Sample Alteration Form

Lower Duwamish Waterway Slip 4 Early Action Area No. A00-06-10C

Figure 1. Location of Proposed Bank Samples

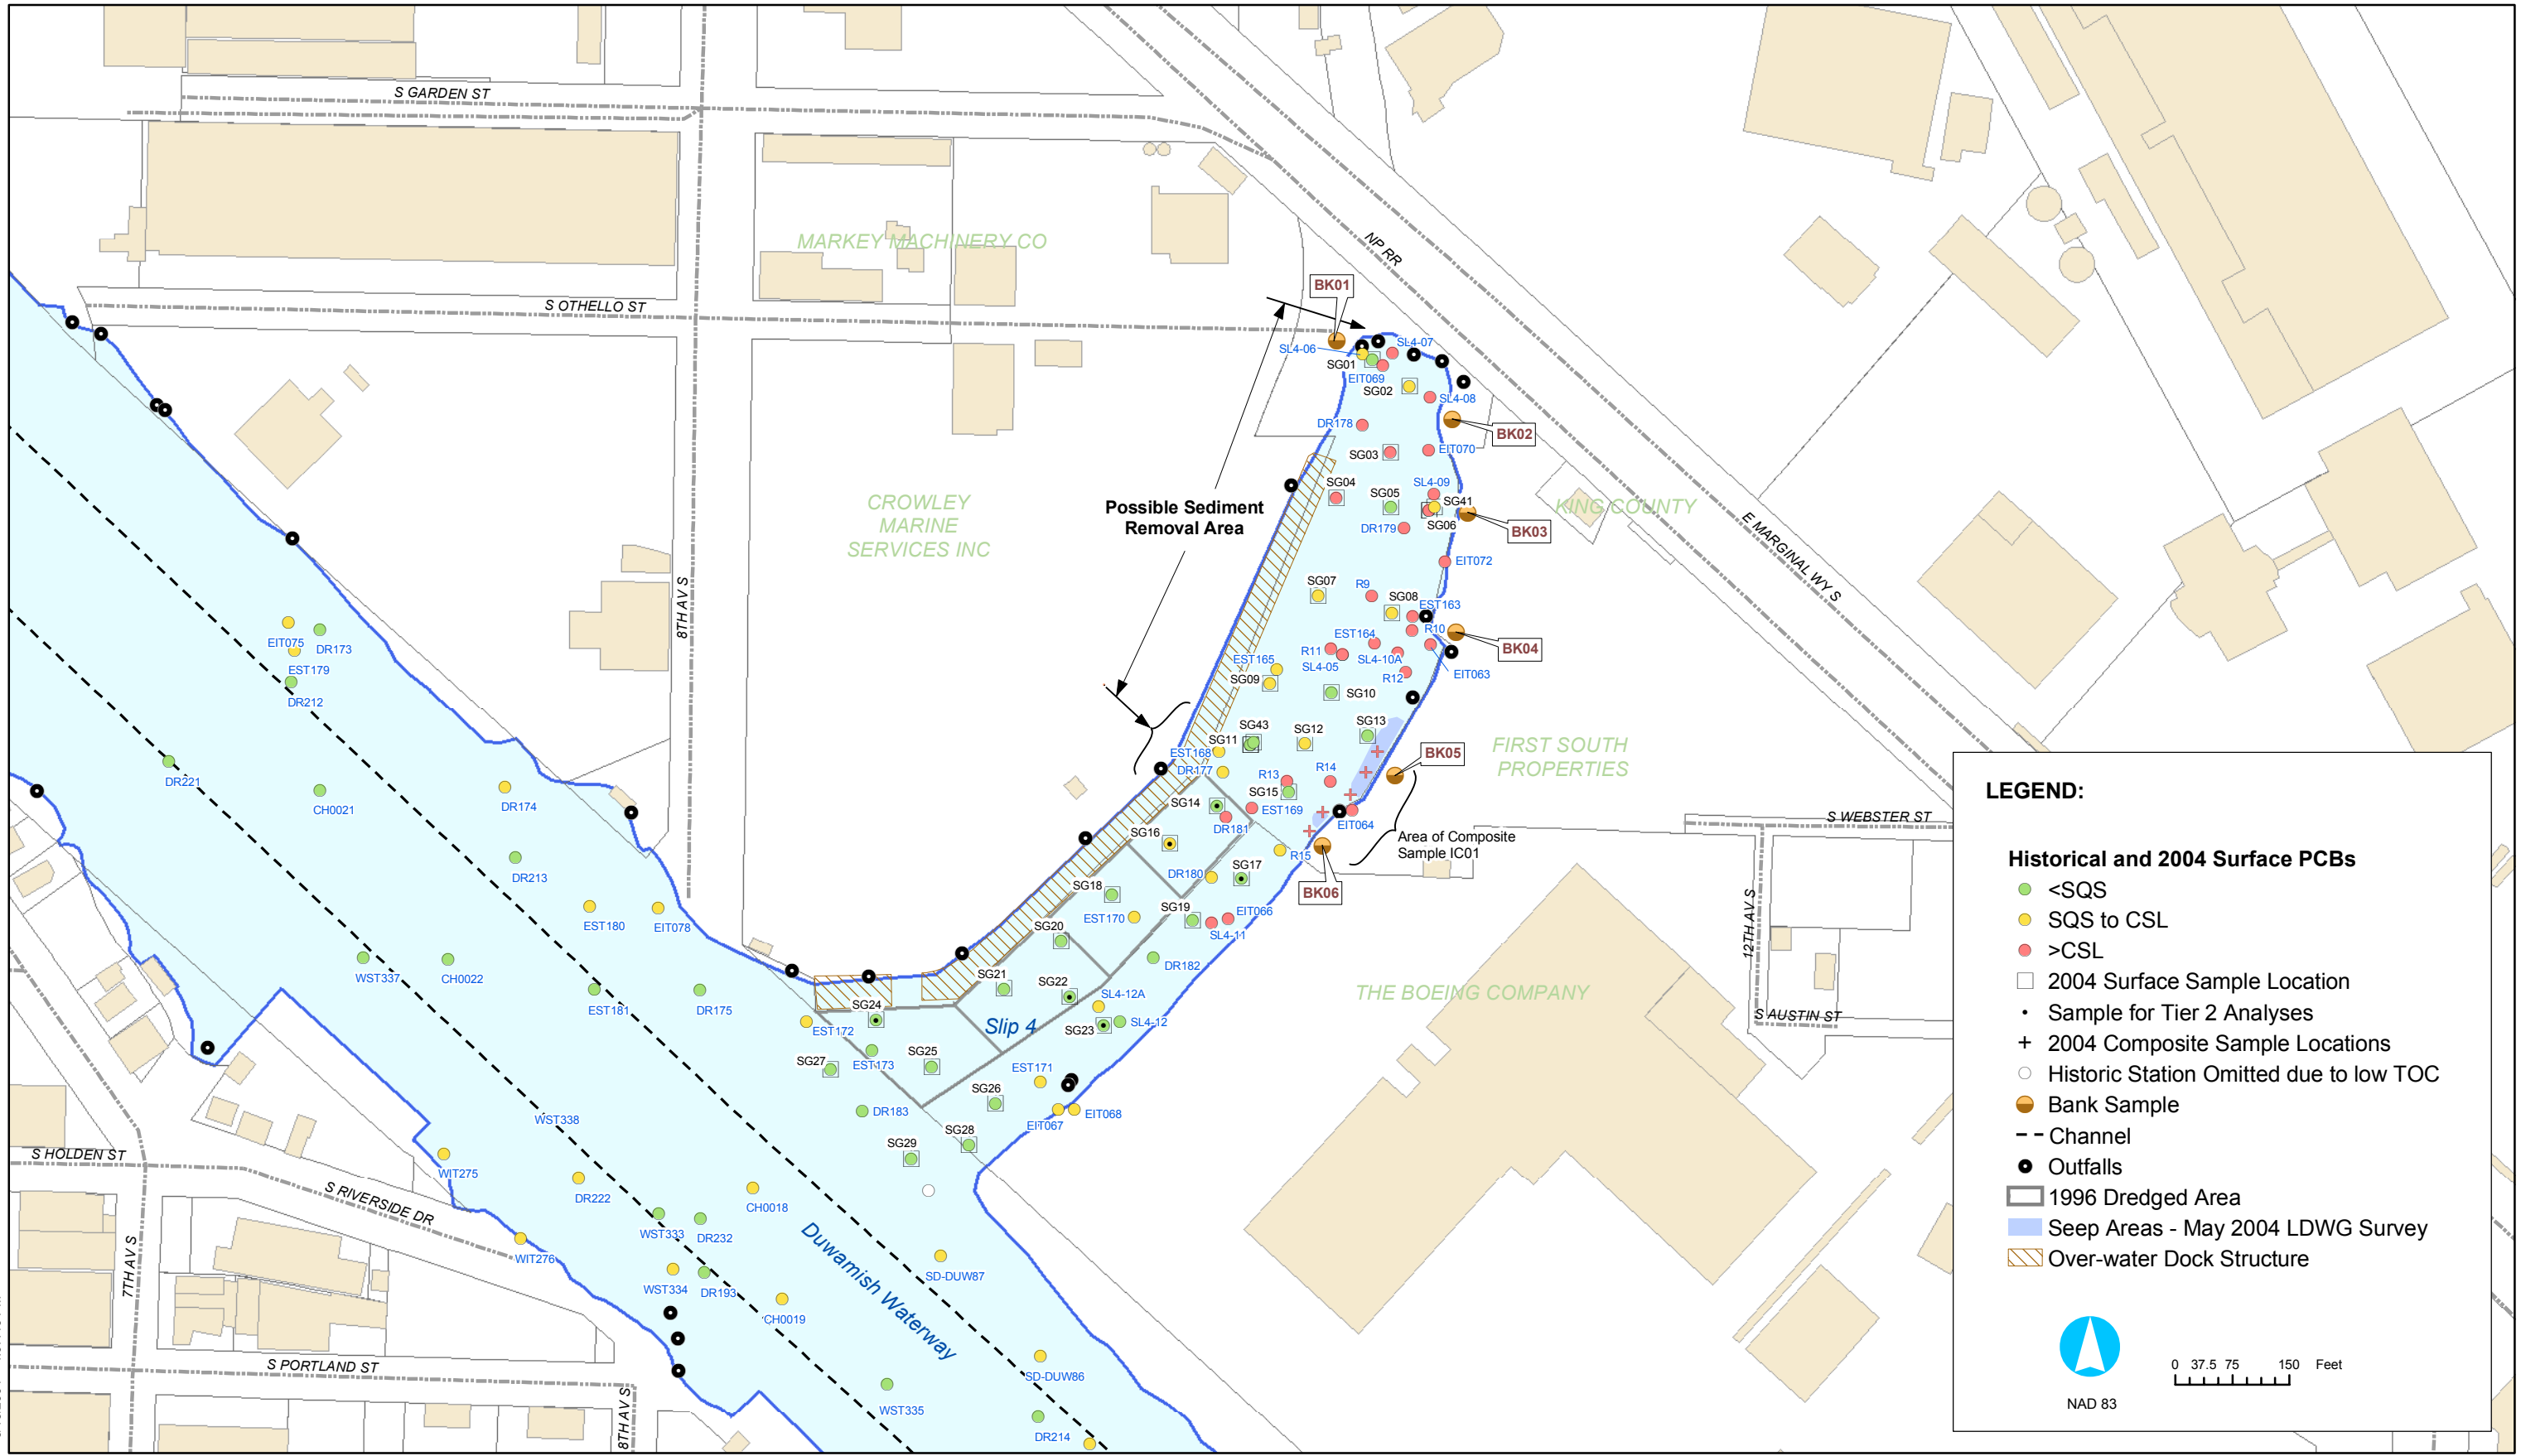
Bank samples will be collected from six locations within Slip 4 (Figure 1). These locations are located along the Slip 4 shoreline in areas where 1) the shoreline is exposed (i.e., isn't covered by either rip rap or the Crowley pier), 2) there are potential upland sources of contaminants, and 3) sediments contain elevated concentrations of PCBs based on either the 2004 or historical data sets. The rationale for specific stations is listed in Table 1.

The bank samples will be identified by the use of "BK" as second part of the sample identifier number. Station numbers are shown in Figure 1.
